SAN FRANCISCO UNIFIED SCHOOL DISTRICT 2011 PROPOSITION A BOND PROGRAM

George Peabody Elementary School New Multipurpose Building and Modernization

ADDENDUM NO. 3

PROJECT: George Peabody Elementary School DATE: August 9, 2013

Design No: 085419A - Bill of Materials

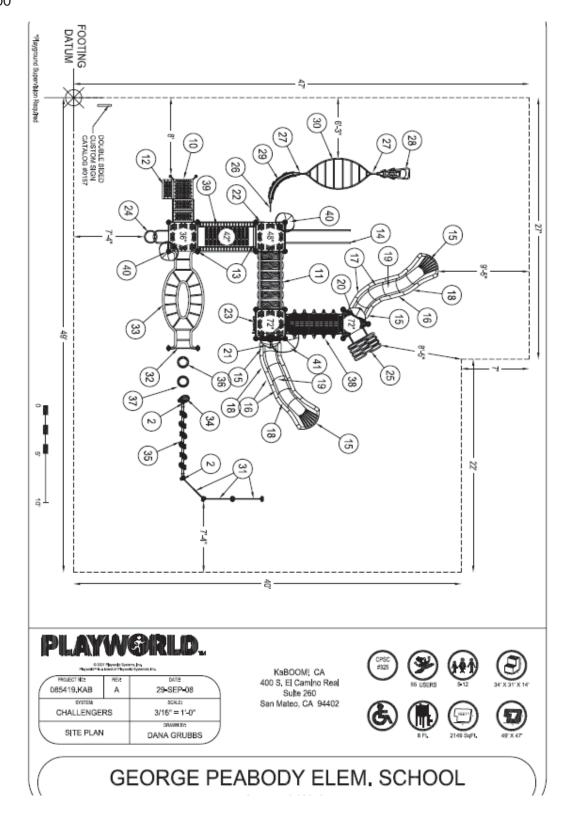
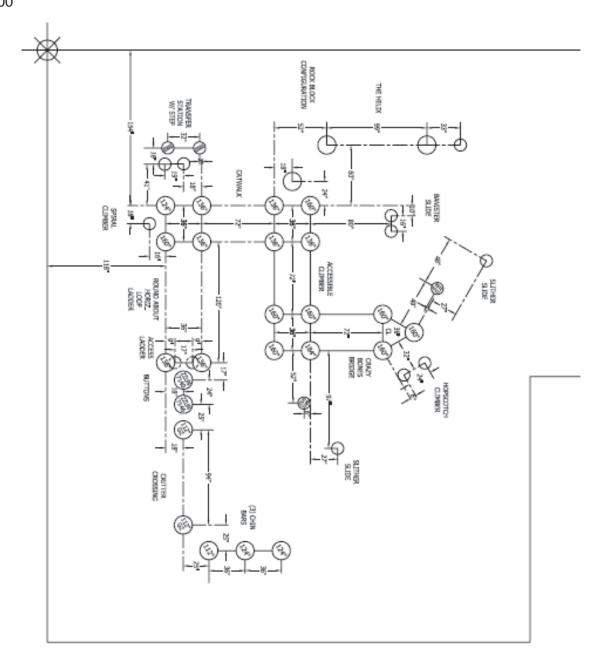
- A. Existing equipment is Playworld System (www.playworldsystems.com) and was installed in 2008. Any additional parts required for complete installation to be by same manufacturer and in the same color scheme as existing.
 - 1. For reference see original bill of materials and parts layout of existing play structure, included in this section. Note not all parts are required to be reinstalled, per plans:

A. Existing structure to be removed, salvaged, and dismantled by the same company that will be doing the reinstallation. See plans. Parts to be re-installed include posts, decks, panels, slides, climbers, etc. Salvage all parts as required for complete installation of the various play stations.
